**Item 3.****Development Application: 242 Cleveland Street, Surry Hills - D/2020/1361**

File No.: D/2020/1361

**Proposal Summary:** Alterations and additions to the Cathedral of the Annunciation of Our Lady; alterations and additions to former St Paul's rectory for use as a chapel, Dean's residence, offices and college domiciles; demolition of existing function hall and parish hall; construction of two new buildings with shared basement for use as place of public worship, shared function spaces, museum, library, office, and theological college, domiciles and shared facilities.

**Figure 37:** Stormwater Concept Plan showing proposed OSD tank and the proposed tree.

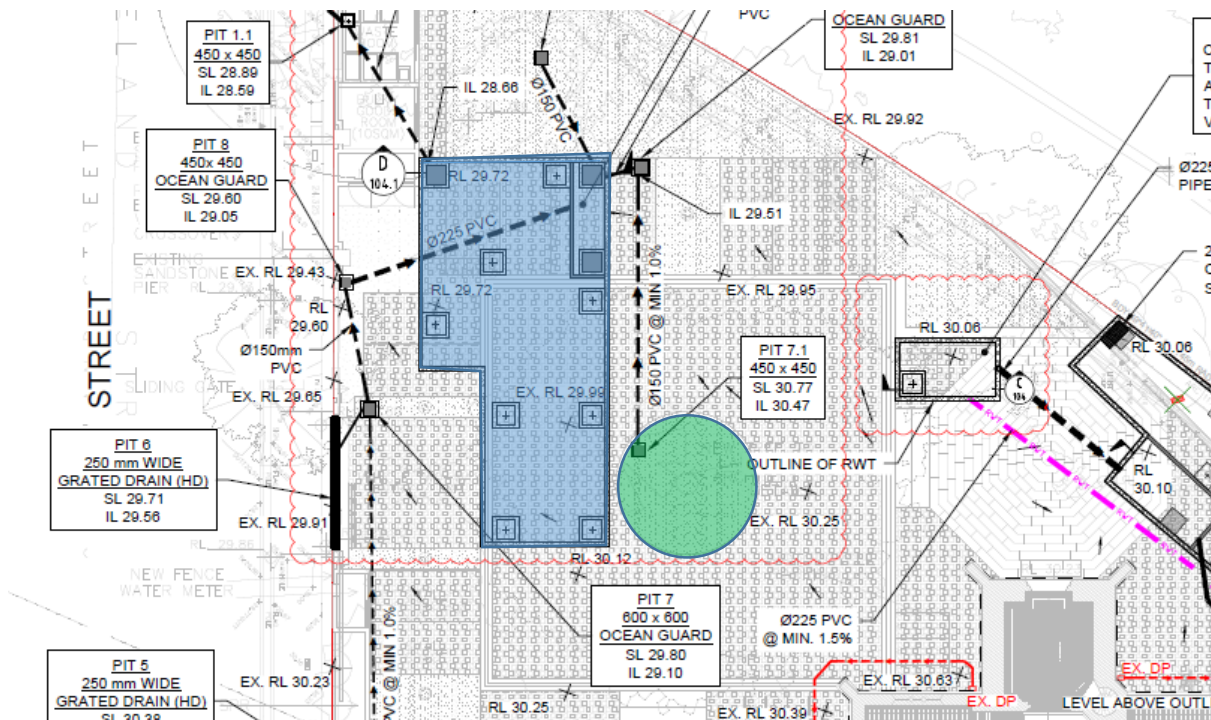
117. While not shown on the submitted architectural plans, or the landscape plan, a large on-site detention (OSD) tank is shown on the submitted stormwater concept plans. The OSD tank is proposed within the courtyard, in proximity to the proposed mature replacement tree. This is illustrated in Figure 37 below. The OSD tank is shown in blue, and the root ball of the mature tree (at installation) is shown in green.

118. The current placement of the tank is likely to result in future damage to the OSD tank from root growth. It will also impede future growth of the tree by limiting the root system. A condition of consent is therefore recommended, requiring the landscape plans to be updated to illustrate the final location of the OSD tank in a position that will not compromise the tree.
